Interim Reclamation and Stormwater Inspection

Operator: RED HAWK PETROLEUM LLC - 10503

Location ID: 433082

Inspection Photos
Location Name: Wickstrom 18 1H
Location ID: 433082

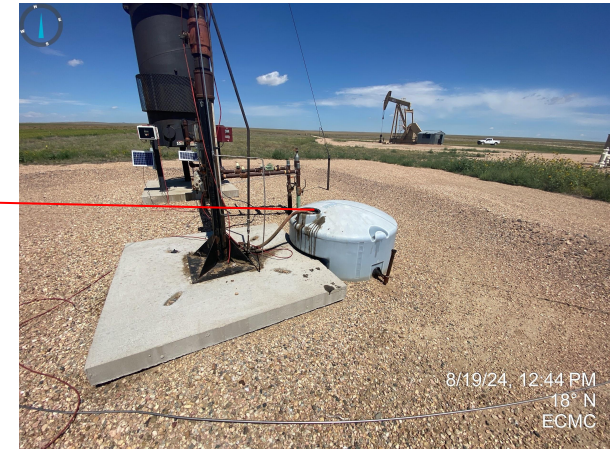
Photo 9. Tank/Container at flare unit does not have adequate wildlife BMPs to prevent or exclude entry by wildlife. Red arrow indicates wildlife mortality (unidentified bird) within container contents. Oily waste shall be removed and wildlife BMPs installed.
